**GS# 104-215 Jones Hall Interior Renovations  
Mississippi University for Women**

Addendum No. 2

SHEET **E301**

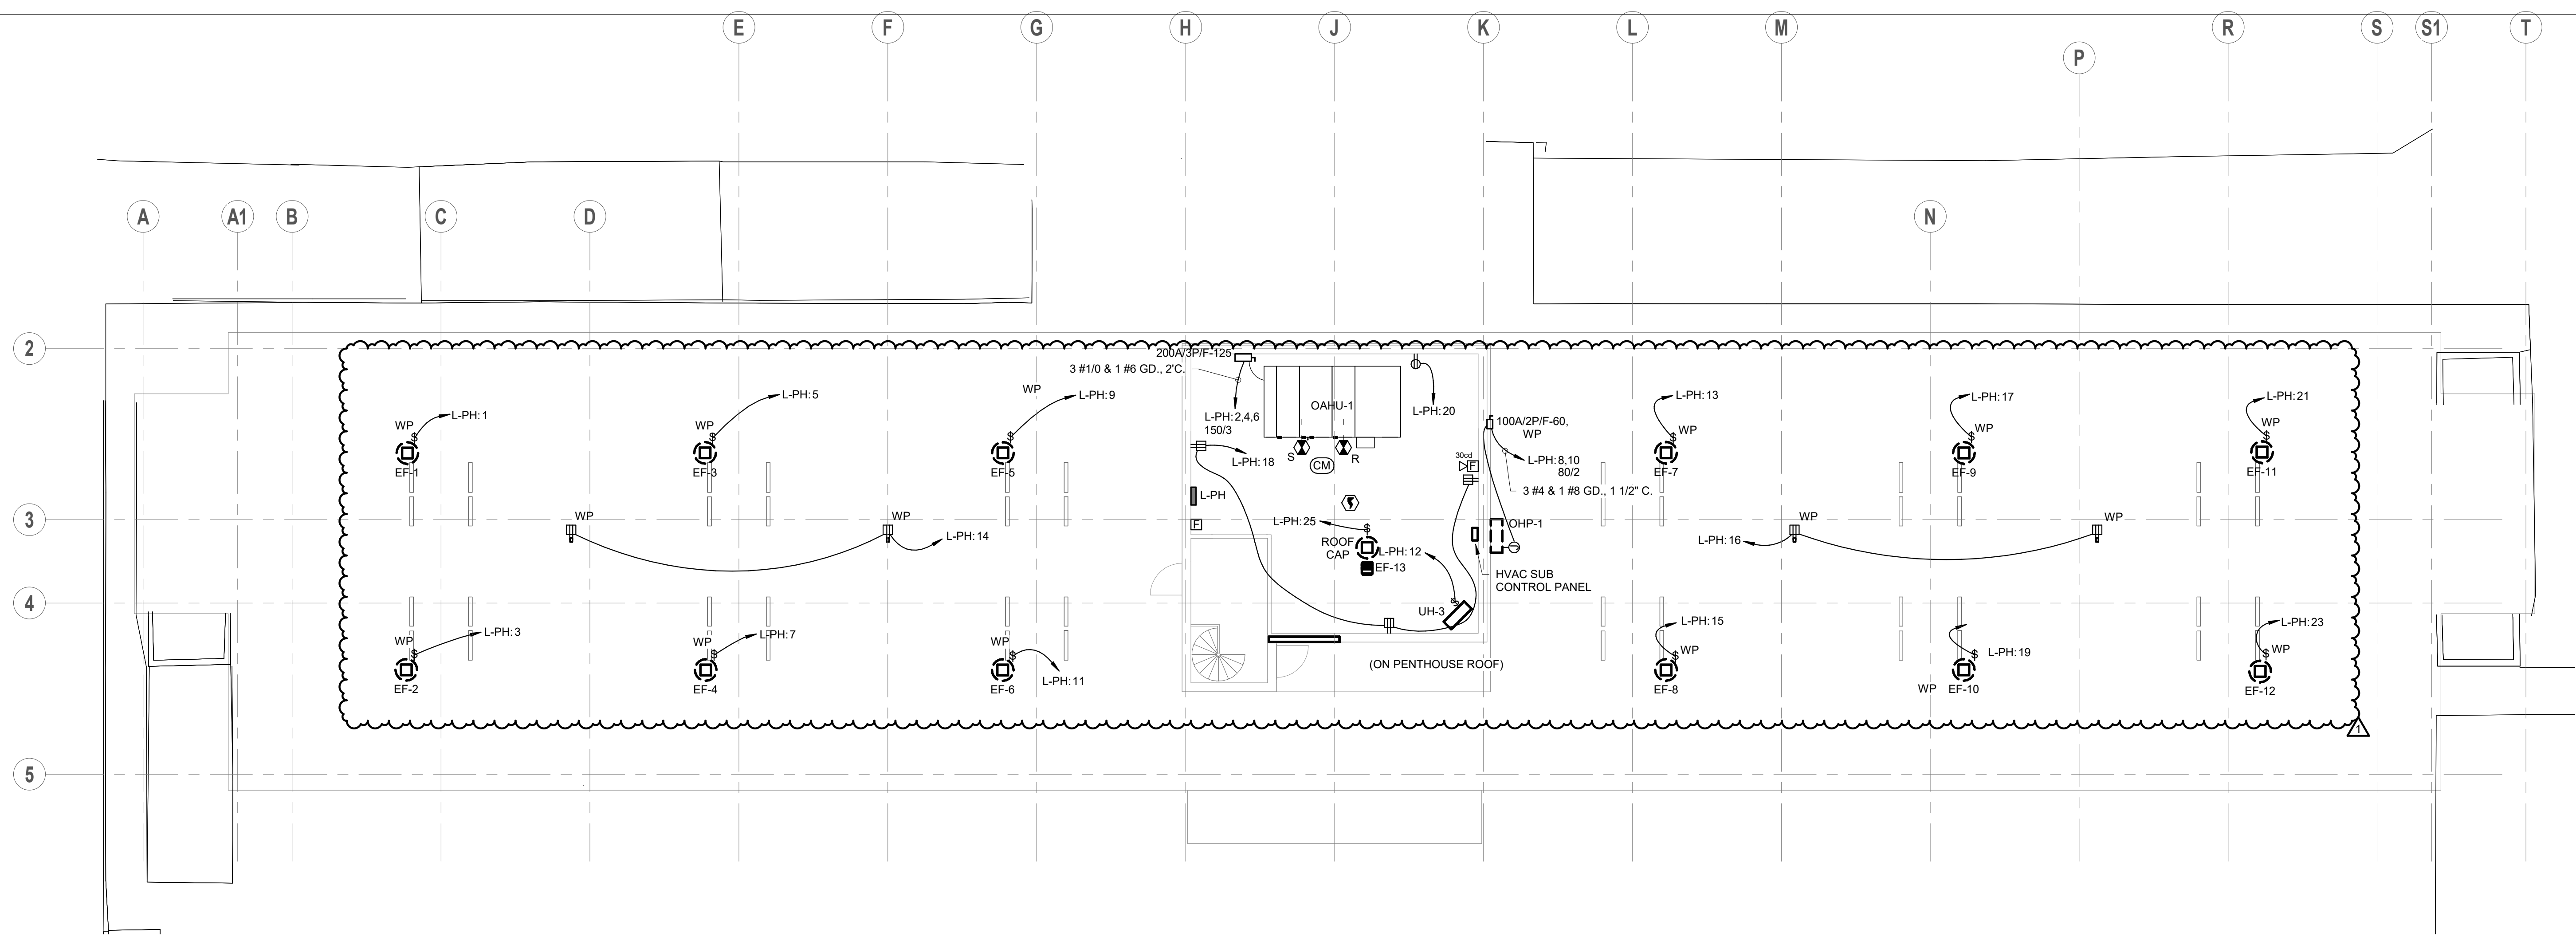
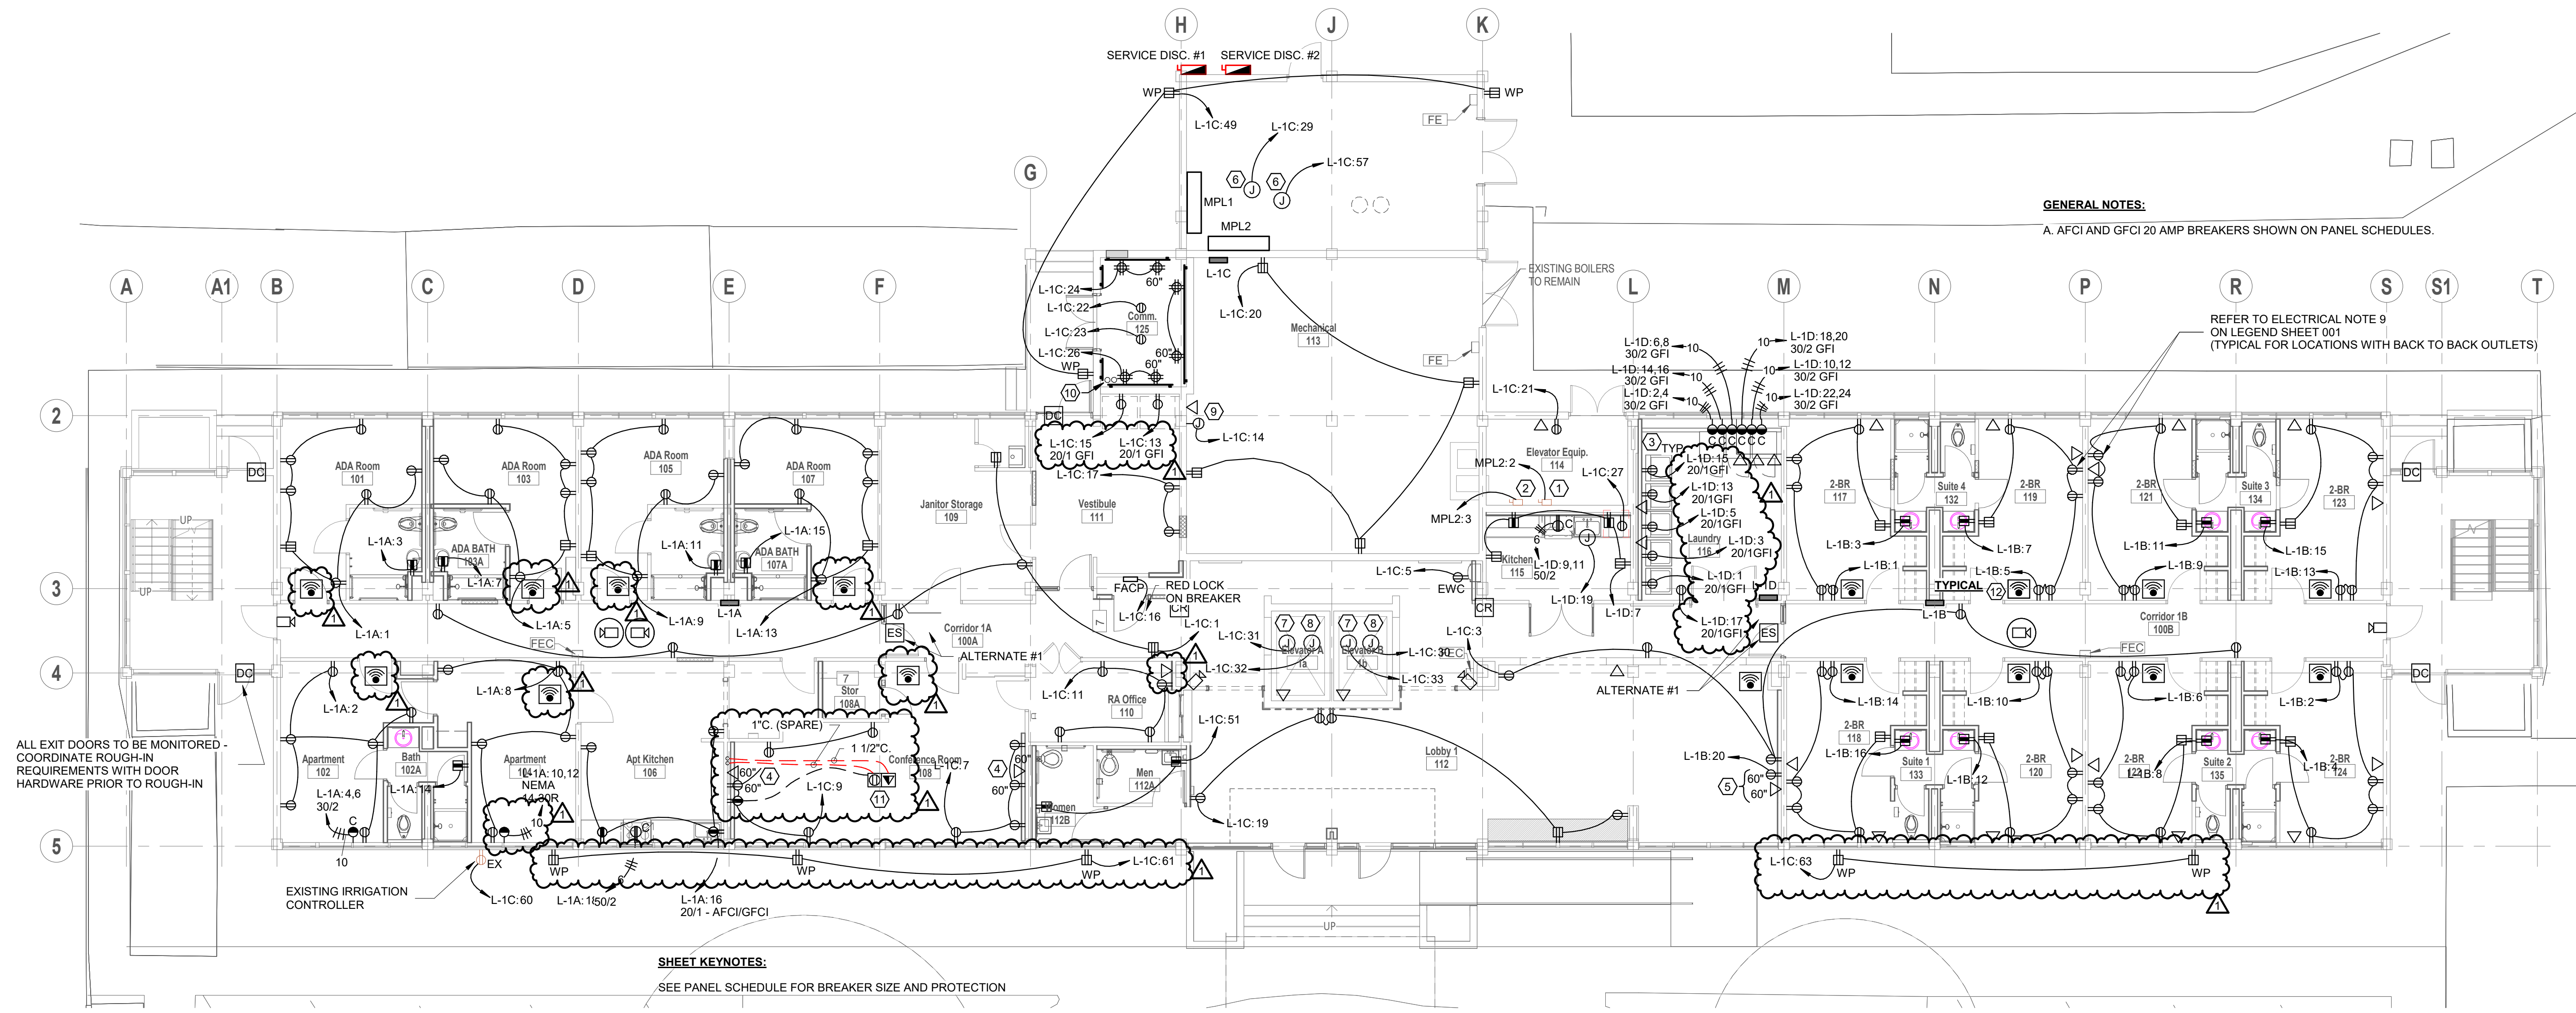
- t. Revise Sheet E101 and replace with attached Sheet E101. Revisions include adding a note to show existing boiler location.
- u. Revise Sheet E301 and replace with attached Sheet E301. Revisions include adding WAP devices to each ADA room. GFI breakers show on plan for vending machines and washer/dryers in Vestibule 111 and Laundry 116. Data device added to RA Office 110. Convenience receptacles added to the front exterior of the building.

**1** ELECTRICAL - ROOF AND PENTHOUSE PLAN  
 E306 1/8" = 1'-0"  
 NORTH

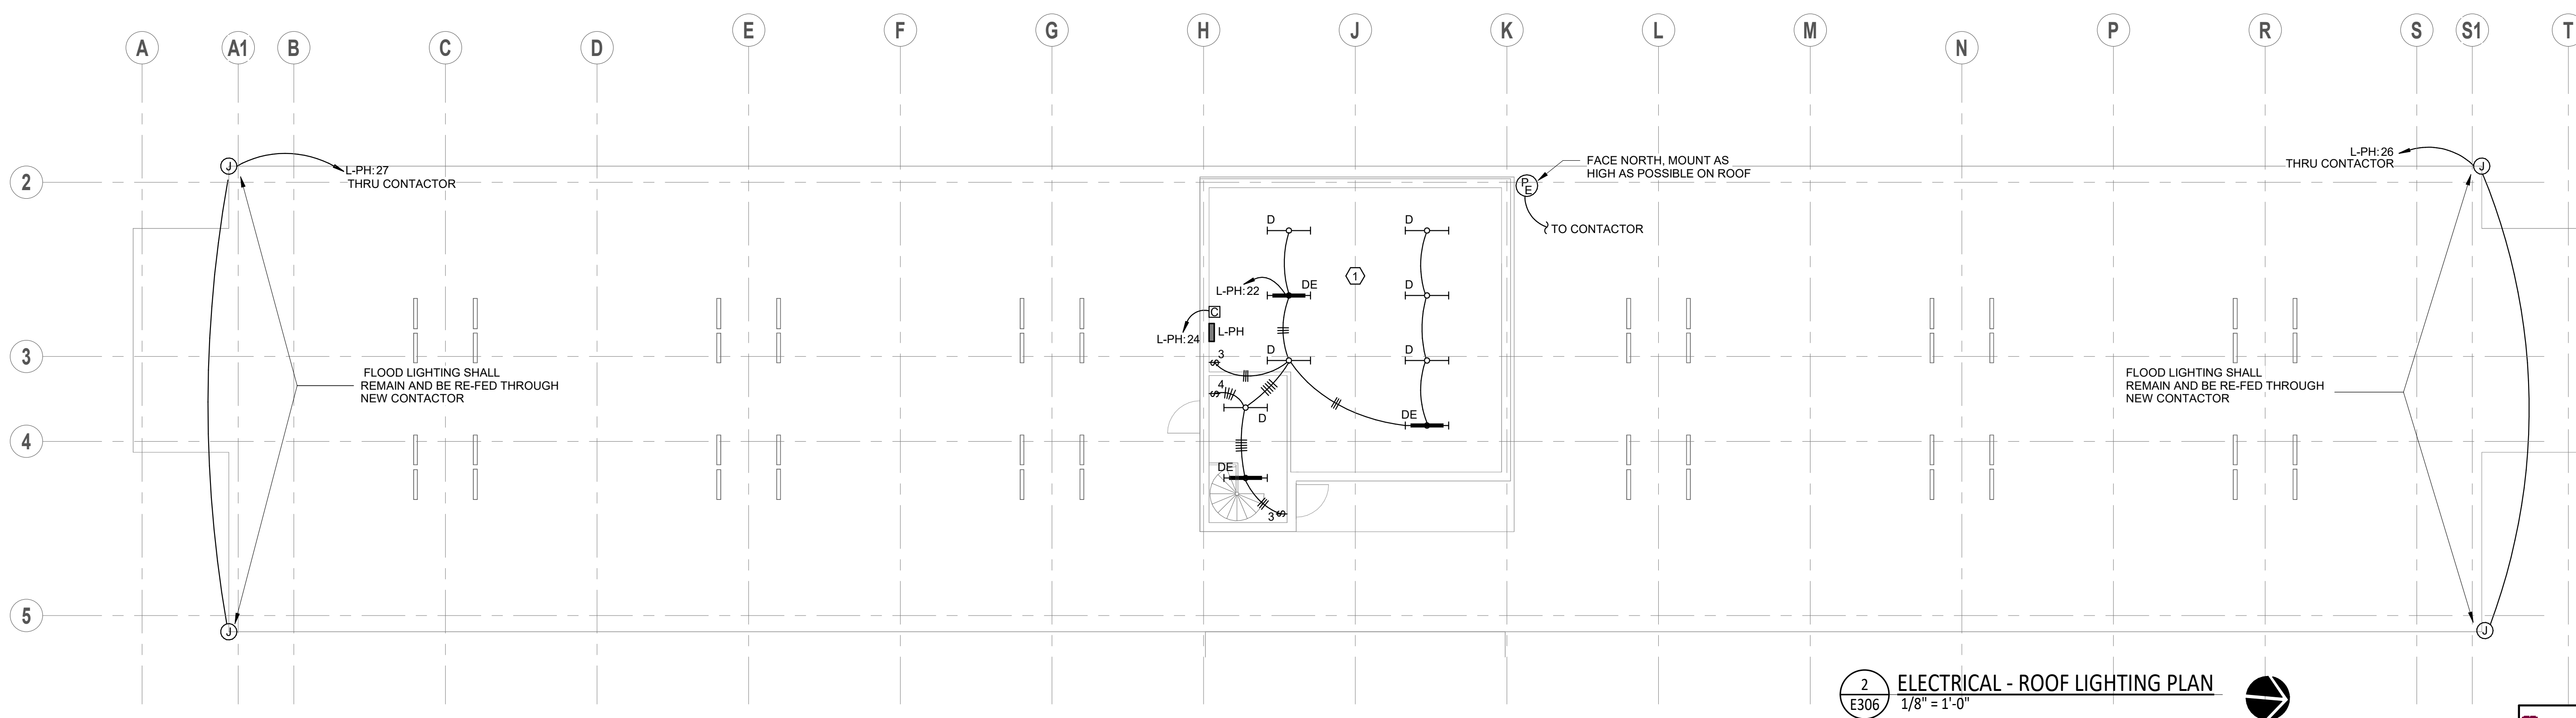
- v. Revise Sheet E306 and replace with attached Sheet E306. Revisions include adjusting the locations of the exhaust fan power to coordinate with mechanical changes. Fire alarm devices and duct detectors added to the penthouse building. Relocated HVAC control panel for OAHU-1 per mechanical changes.

**FIRE ALARM - 1ST FLOOR PLAN**

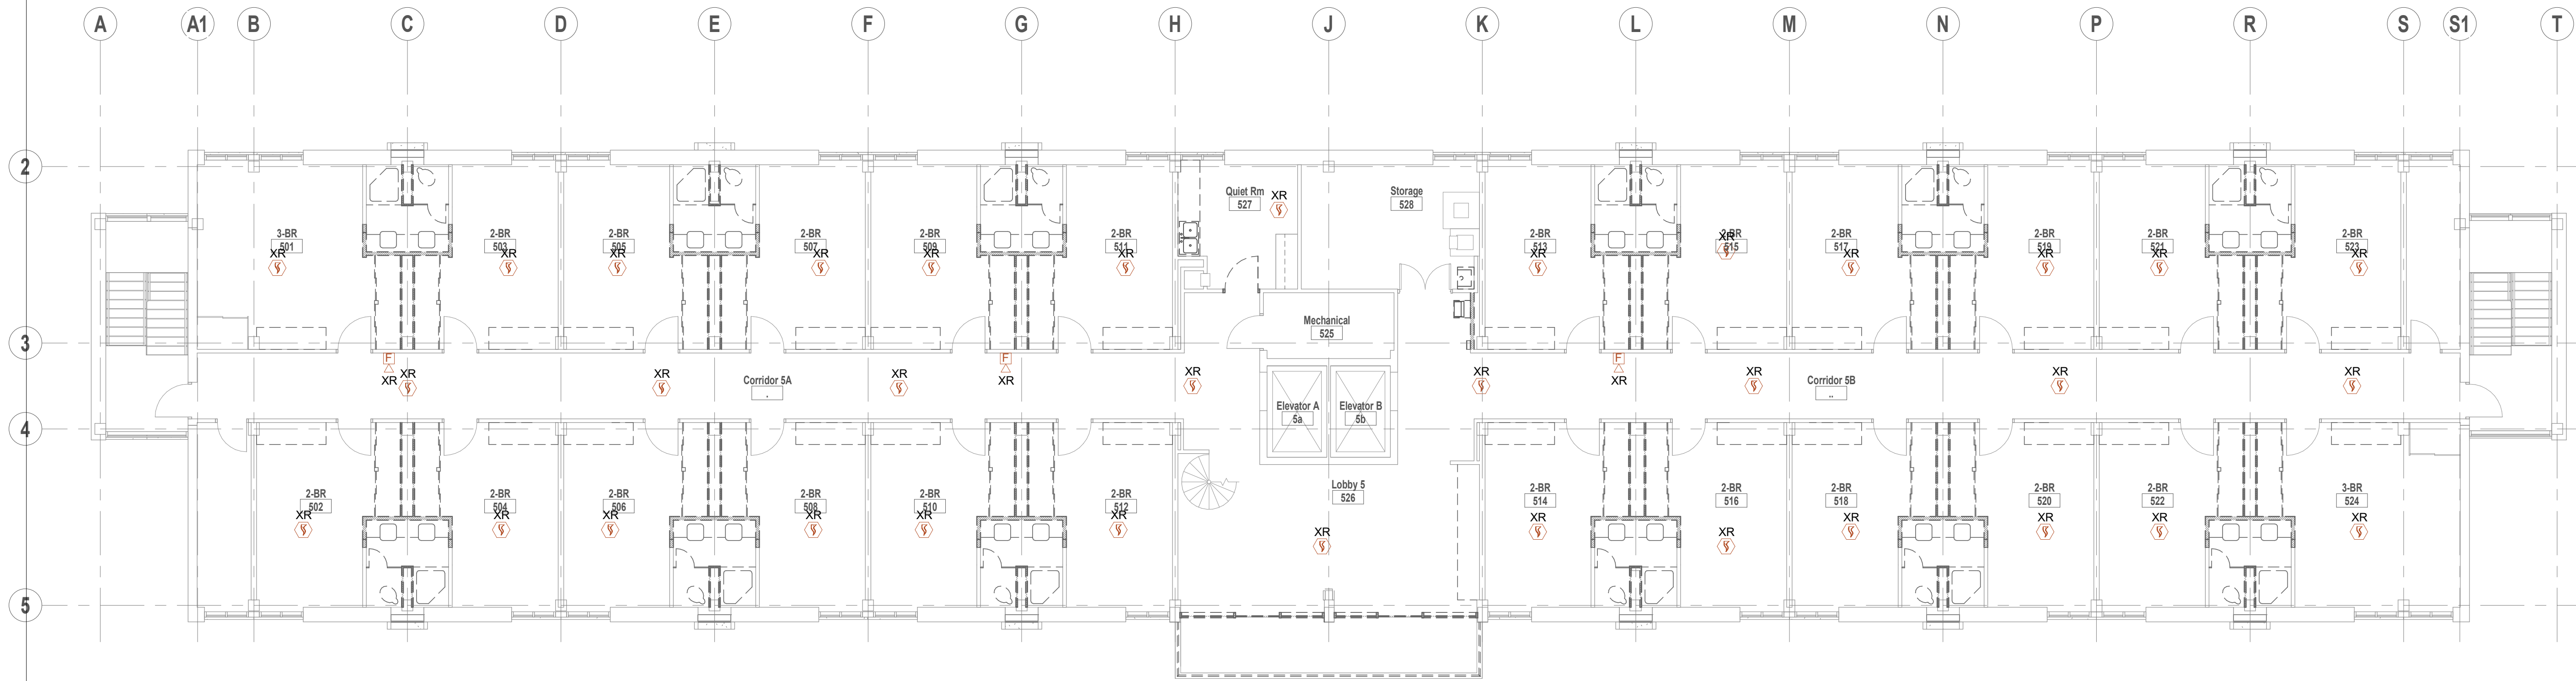
- w. Revise Sheet E401 and replace with attached Sheet E401. Revisions include adding flow and tamper switches to the bottom of elevator shaft.
